ADDENDUM NO. 1 TO PROJECT NO. 44559

**CONSTRUCTION WORK, HVAC WORK, PLUMBING WORK, AND ELECTRICAL WORK
PROVIDE STATE POLICE FORENSIC IDENTIFICATION UNIT BUILDING,
HEADQUARTERS ADDITION AND COLD STORAGE BUILDING
TROOP E HEADQUARTERS
1569 ROCHESTER ROAD
CANANDAIGUA, NEW YORK**

February 5, 2016

| DRAWING NUMBER: | C-106 |

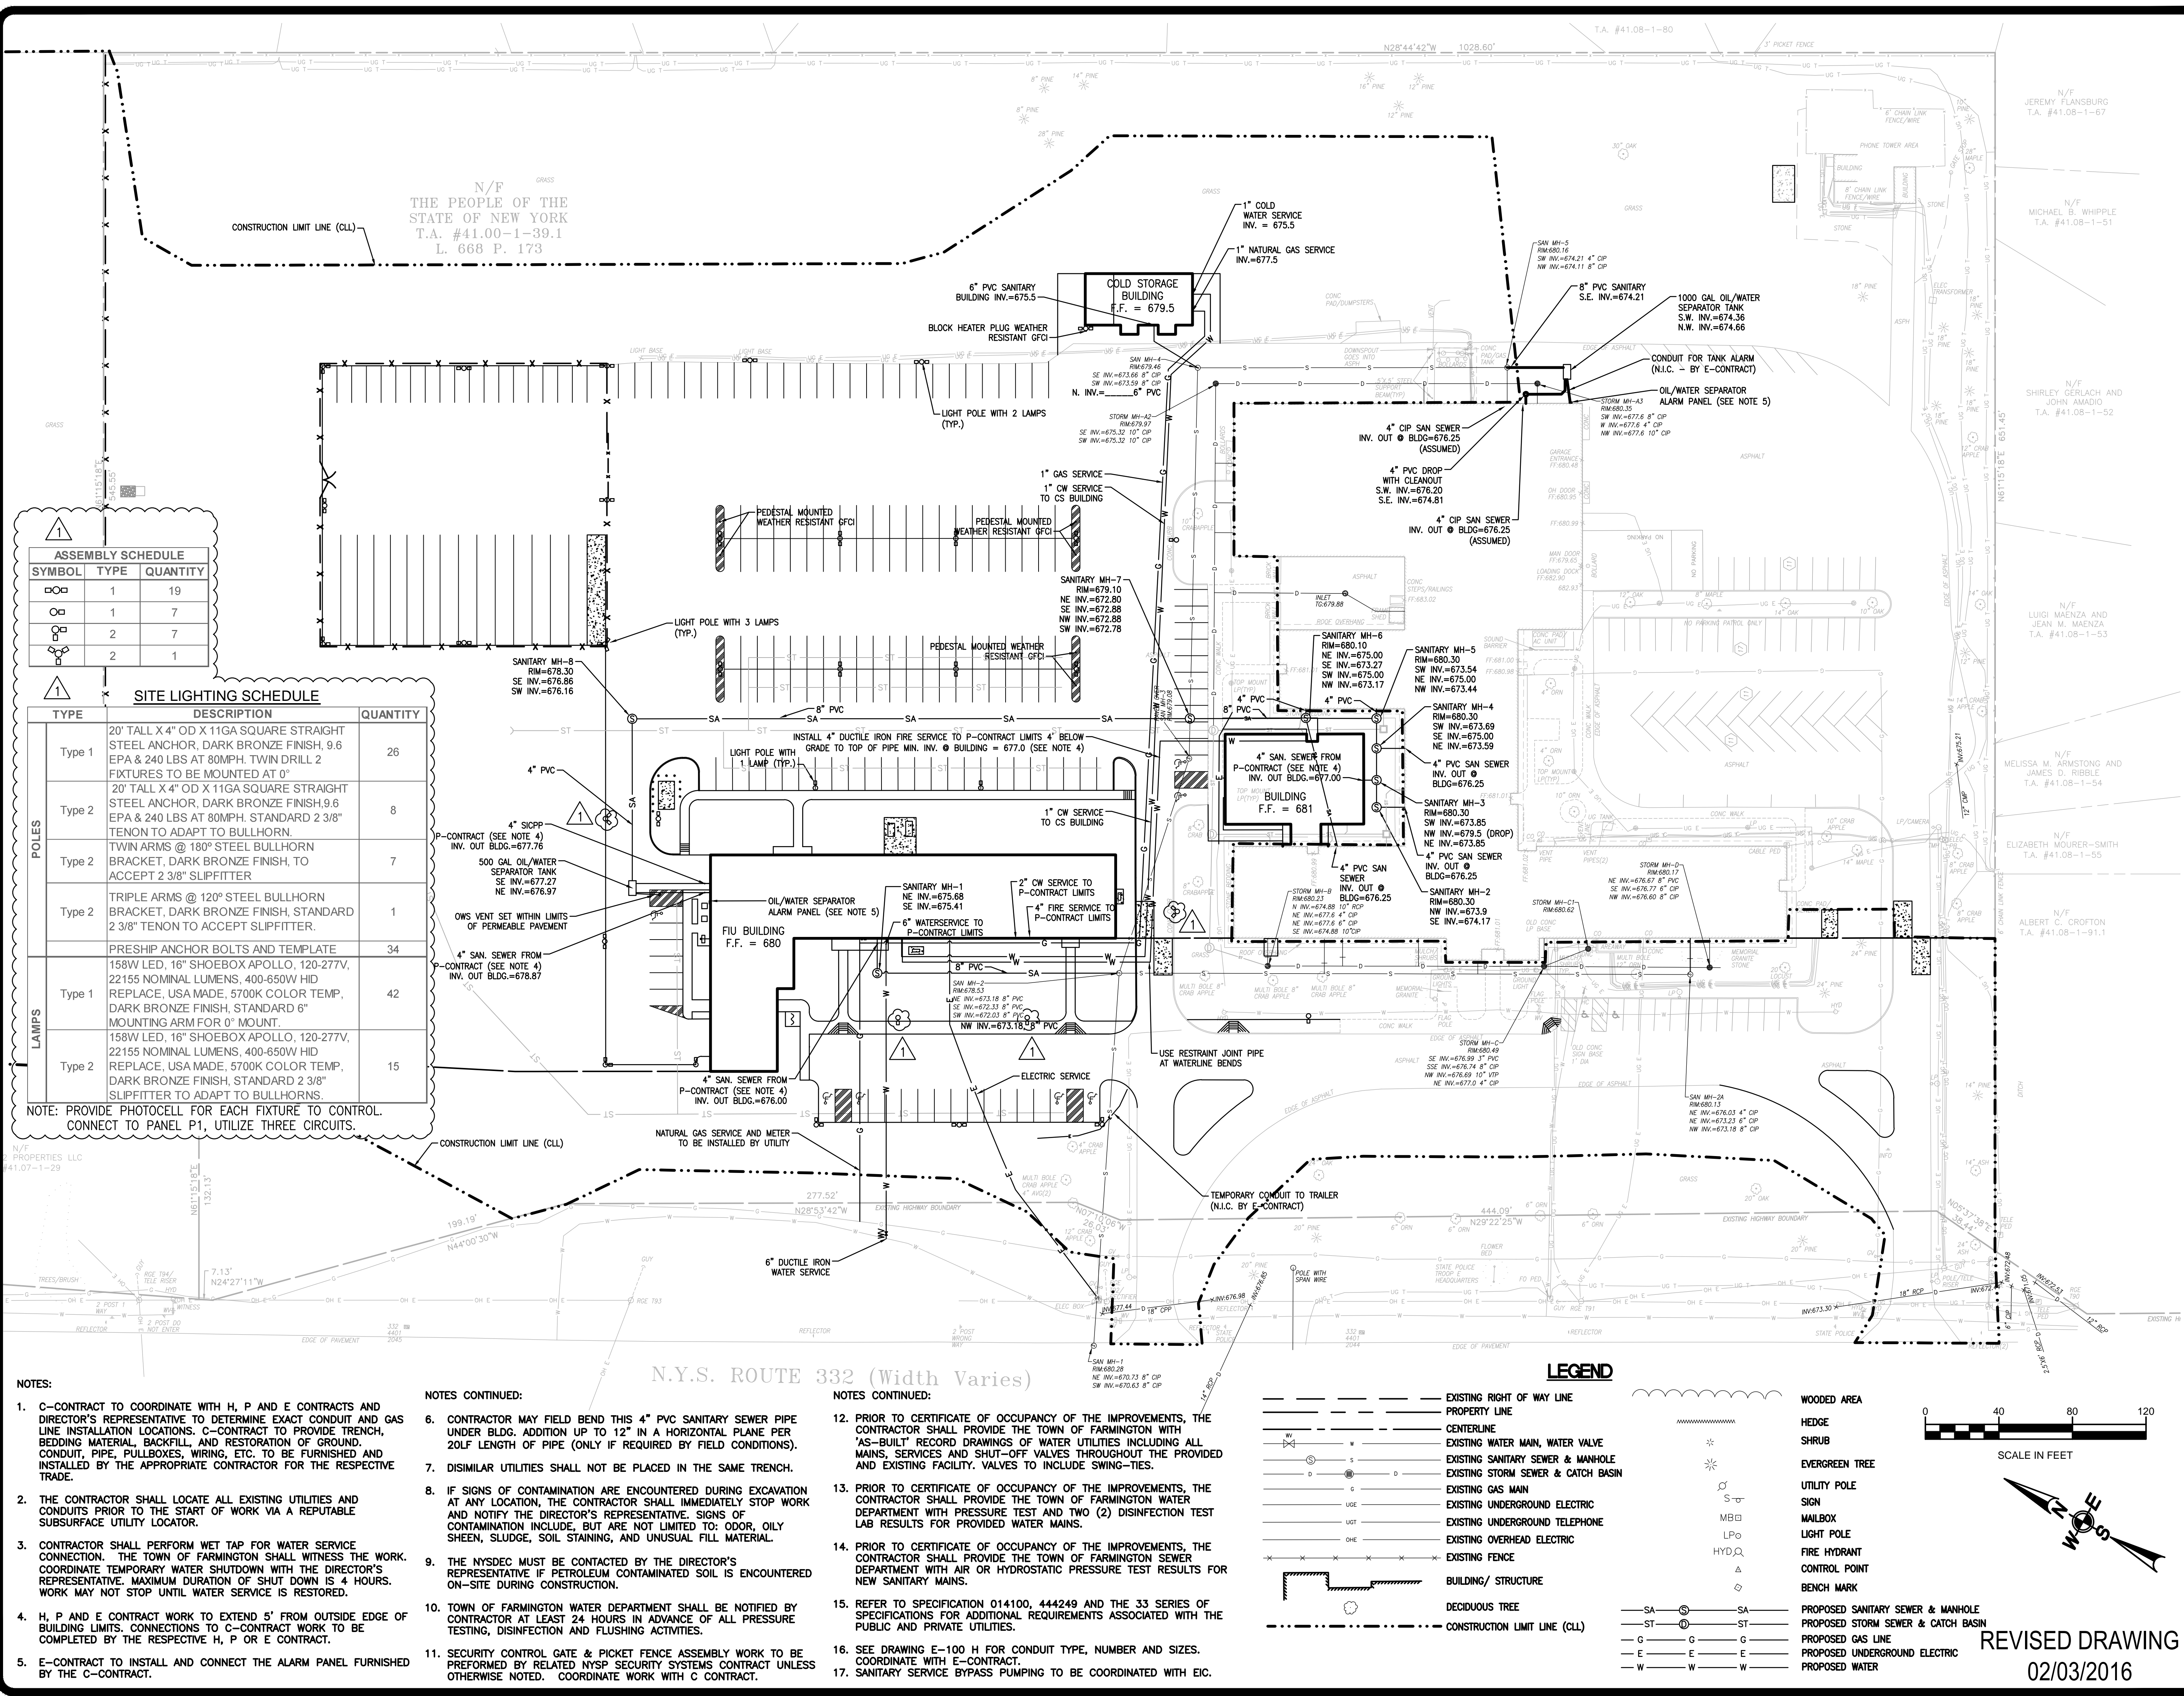
1. Drawing C-106, noted "REVISED DRAWING 2/2/2016" accompanies this Addendum and supersedes the same numbered originally issued drawing.
2. Drawing A-101 F, noted "REVISED DRAWING 2/2/2016" accompanies this Addendum and supersedes the same numbered originally issued drawing.
3. Refer to Drawing A-103 H - PARTIAL FIRST FLOOR REMOVAL PLAN.
